Addendum to IFB

IFB NUMBER: IFB 24-064/MR
IFB TITLE: Popeye Holmes Park Concrete Walkway Renovation
IFB DUE BY: 11:00 am CT, Wednesday, November 13, 2024
ADDENDUM NO.: 2
ISSUED (DATE): November 7, 2024

POPEYE HOLMES PARK
CONCRETE WALKWAY
RENOVATION

DESIGN	J.D.	QUANTITY SUMMARY	SHEET NO. 5
CHECKED	M.F.

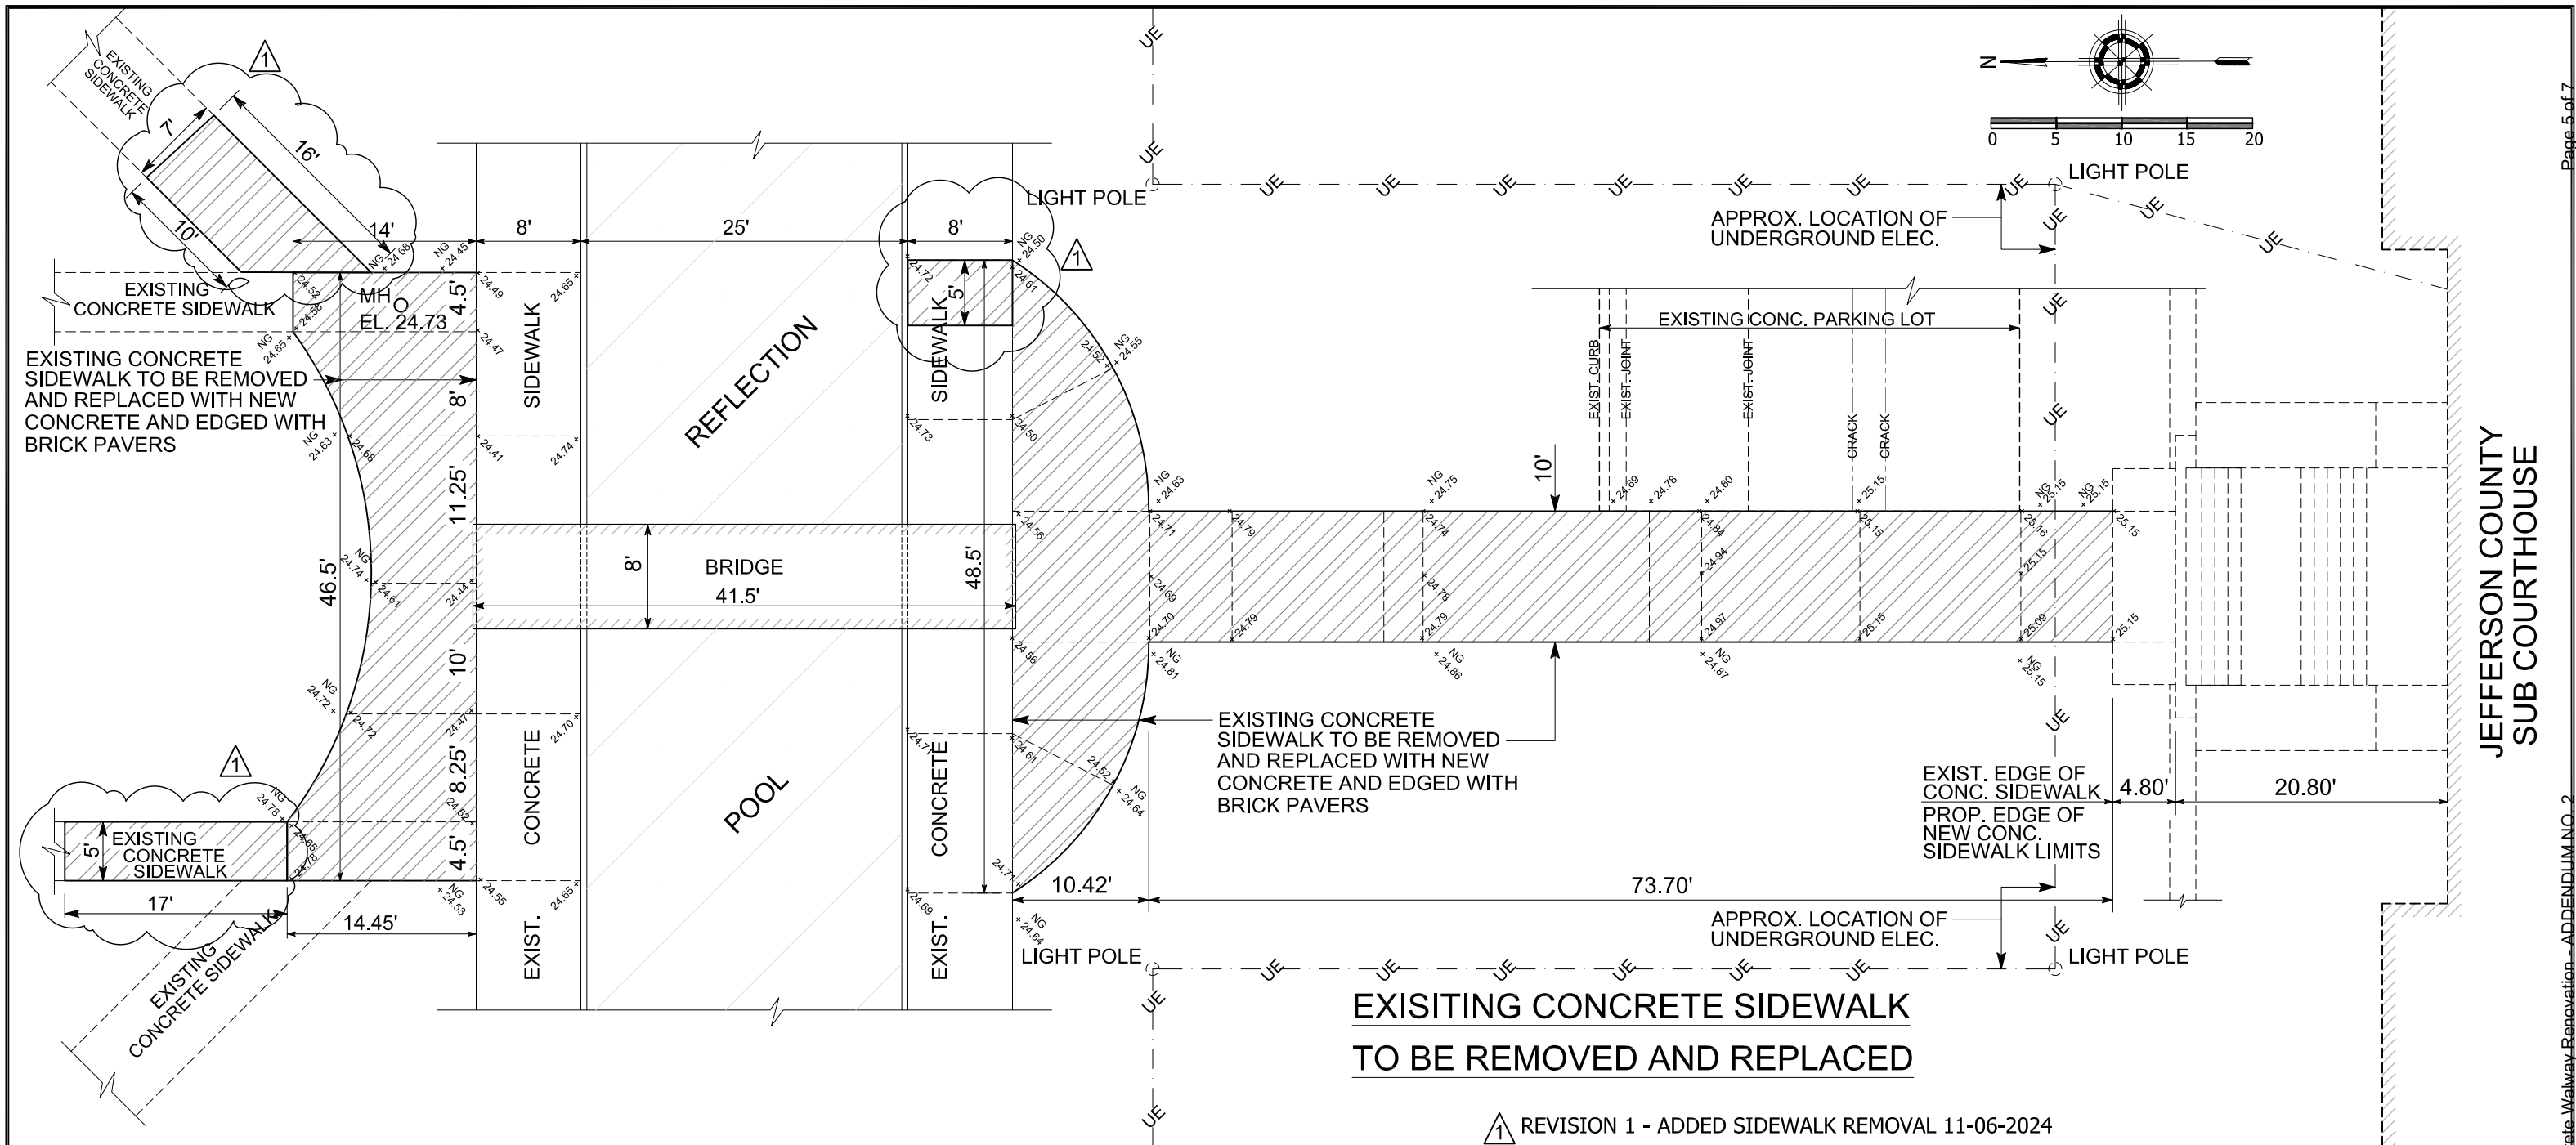
REV1 REVISION 1 - UPDATED QUATITIES FOR ADDITIONAL PAVING AND CORRECTED UNITS FROM SY TO SF. 11-06-2024

EXISTING PLAN

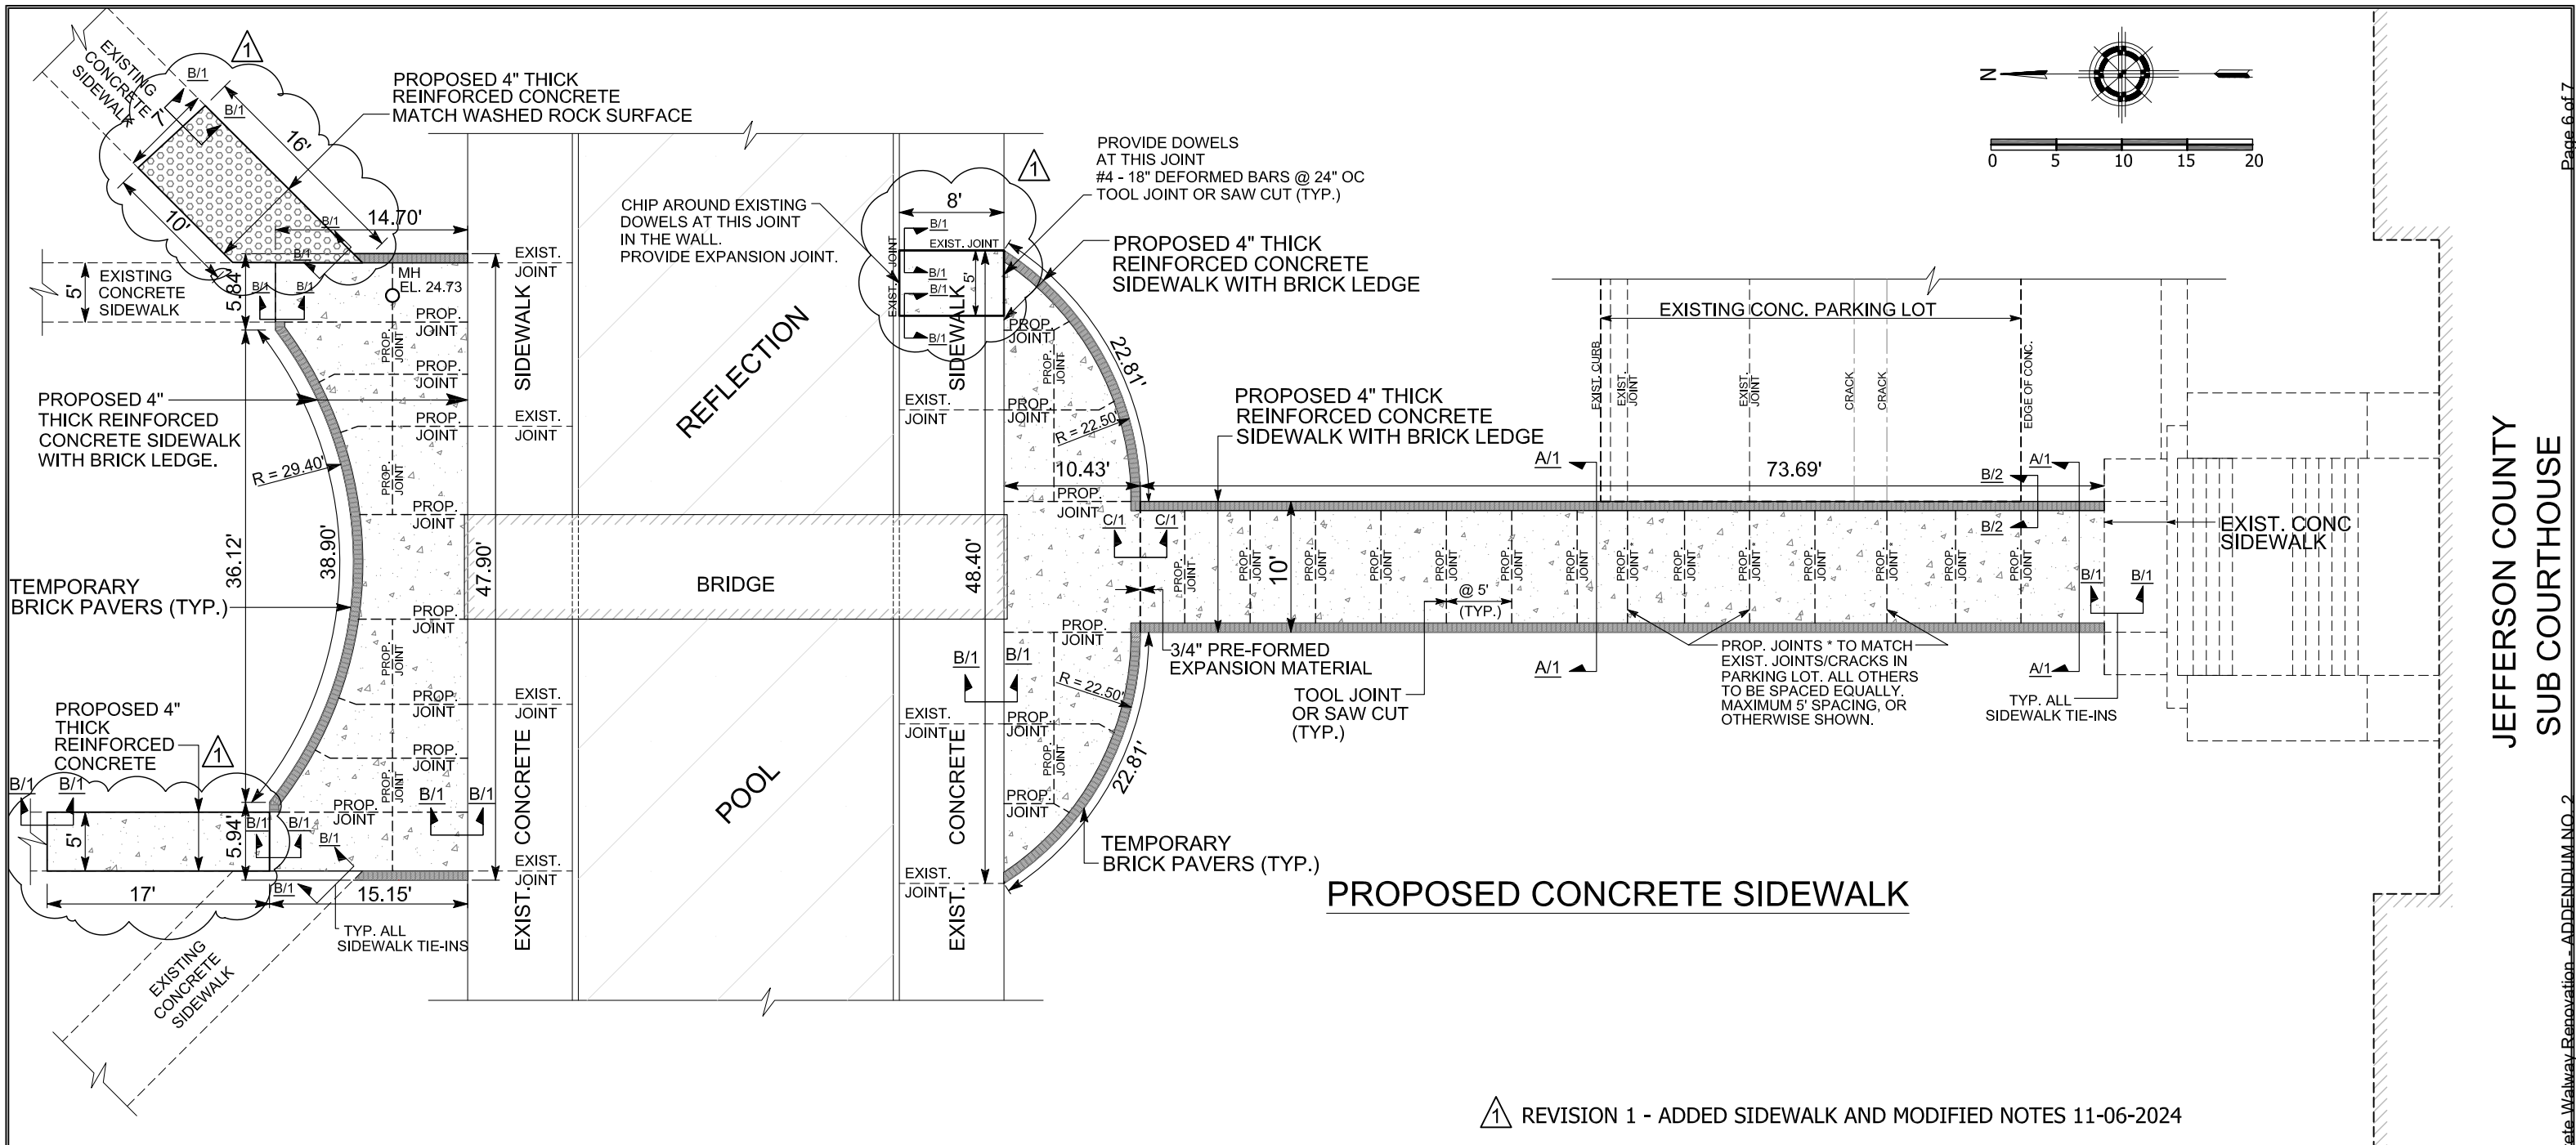
REVISION 1 - ADDED SIDEWALK REMOVAL 11-06-2024

- 1) CONTRACTOR TO FULL DEPTH SAW CUT ALL EDGES AGAINST EXISTING CONCRETE WHERE EXISTING CONCRETE WILL BE REMOVED.
- 2) ANY DAMAGE TO THE EXISTING CONCRETE PAVING OR ANY OTHER STRUCTURES WILL BE REPAIRED TO EXISTING OR BETTER CONDITION AT NO EXPENSE TO THE COUNTY.

BRICK UNIT NOMENCLATURE	DIMENSIONS (W x H x L)	SERIES	TEXTURE	COVERAGE	STOCK AVAILABILITY	WEIGHT
BEAR PATH PAVER	4" x 2-1/4" x 8" (WITH CHAMFERED EDGES & SPACER LUGS)	ELITE	WIRE CUT (OPTIONAL TUMBLED)	4.5 PER SQ. FT (SAND SET NO GROUT JOINT)	NORMALLY STOCKED IN SELECT COLORS	5.9 LBS

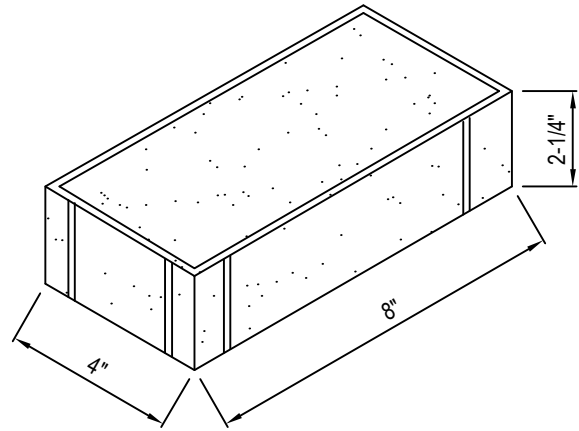
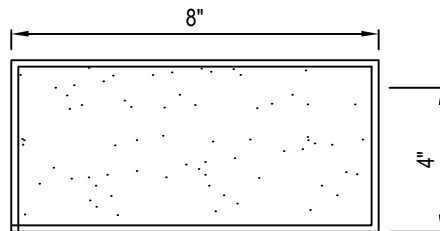
1. Revised Bid Form is on page 3 of this addendum. The unit of measure and quantity of line items 1, 2 & 3 have been revised.
2. Revised Project Plans for sheet 5 (Quantity Summary), sheet 6 (Existing Plan) and sheet 7 (Proposed Plans) have been updated. These revised sheets are on pages 4-6 of this addendum,
3. The specifications for the pavers referenced are on page 7 of this addendum.

- ☒ WIRE CUT **Brick Paver to be wire cut**
- ☐ TUMBLED
